DOCKET 50-155 - LICENSE DPR-6 -  
BIG ROCK POINT PLANT - FIRE  
PROTECTION MODIFICATIONS

Big Rock Point Plant Fire Protection Modifications

Response to Enclosure 1, Paragraph 8, Information Requirements  
of Generic Letter 81-12 dated February 20, 1981

<b>BECHTEL CORPORATION</b> SAN FRANCISCO		
<b>BIG ROCK POINT PLANT</b> CHARLEVOIX, MICHIGAN CONSUMERS POWER COMPANY		
<b>EQUIPMENT LOCATION PLAN ABOVE GRADE</b>		
3159	FORMER DWG. NO. M-100	H

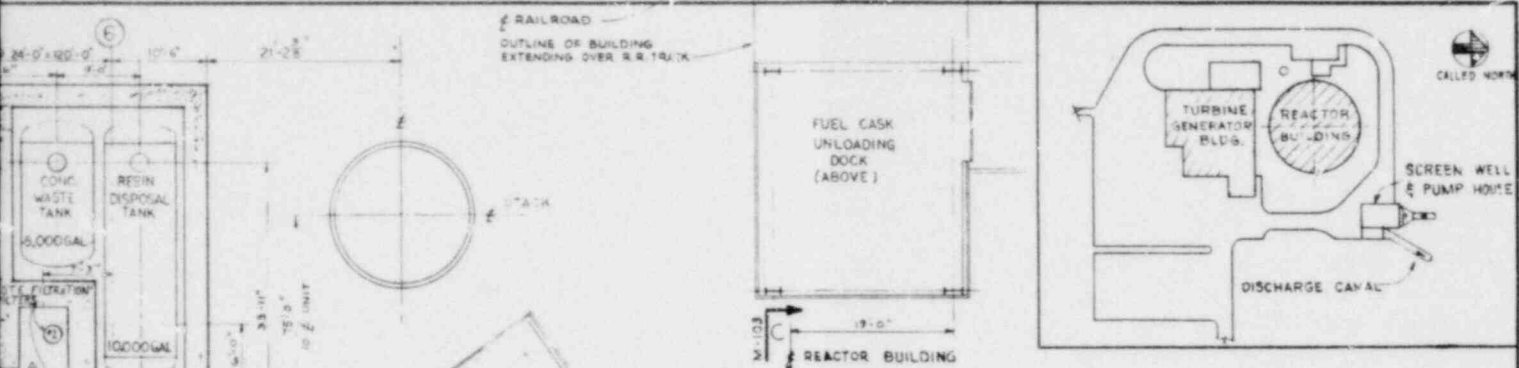
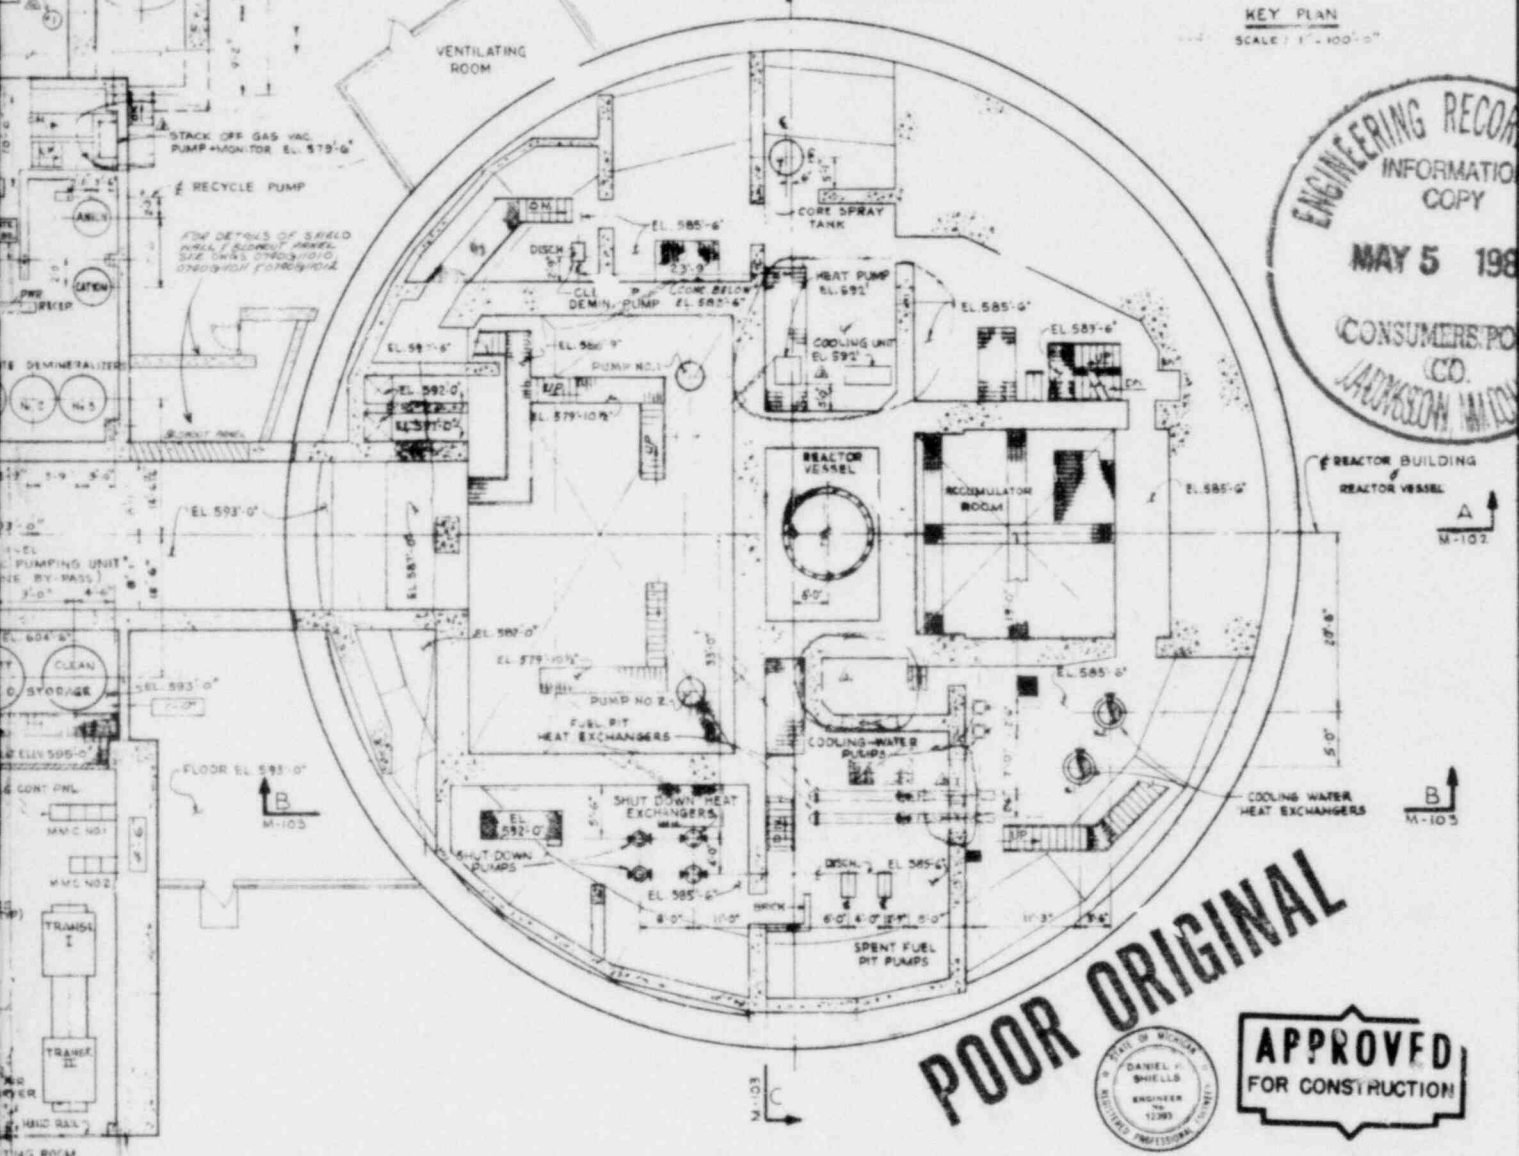
8. (d) Demonstrate that wiring, including power sources for the control circuit and equipment operation for the alternate shutdown method, is independent of equipment wiring in the area to be avoided.

Response: The power supply, actuating devices, controls and other supporting equipment for achieving hot shutdown are located in the core spray equipment room (which is below the fuel cask unloading dock) or the stairwell outside the core spray equipment room. These two areas are below grade and completely separated from the fire areas of concern. See attached Drawing M100 - Equipment Location - plan above grade.

FIGURE 1

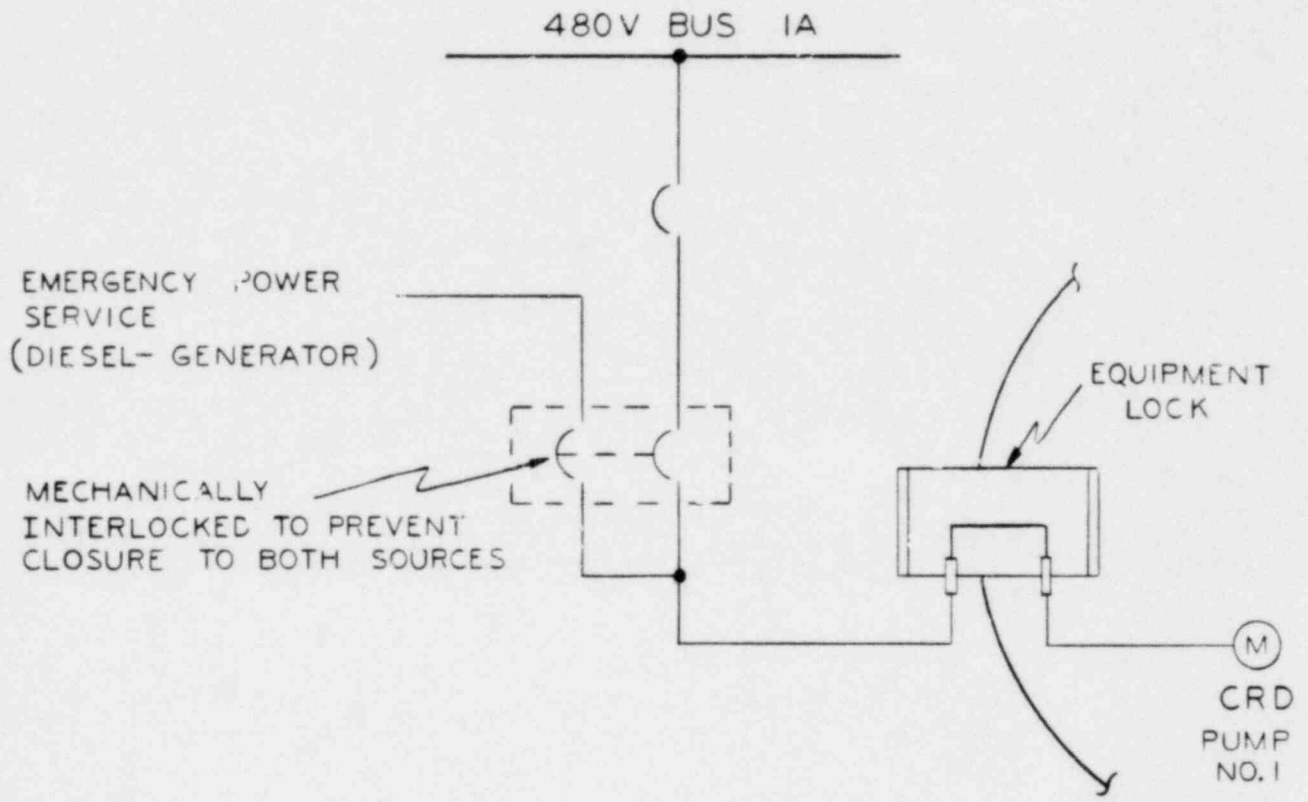
8. (a) Description of the systems or portions thereof used to provide the shutdown capability and modifications required to achieve the alternate shutdown capability if required.

Response: The description of the modifications for the assurance of safe shutdown - required by 10CFR50, Paragraph 50.48 - was submitted by Consumers Power Company letter dated March 19, 1981. Subsequent to the submittal of this description, a change in the planned modification has been made which affects the normal power supply to Control Rod Drive (CRD) Pump #1. This pump will be supplied from its present source via a feeder cable routed through the equipment lock. On the outside of containment and the lock at or near the electrical penetration, a dual, interlocked, nonautomatic circuit breaker will be installed. The breaker will switch the motor to either its normal source or an alternate source. Attached Figure #1 illustrates this concept. See also response to 8(1).
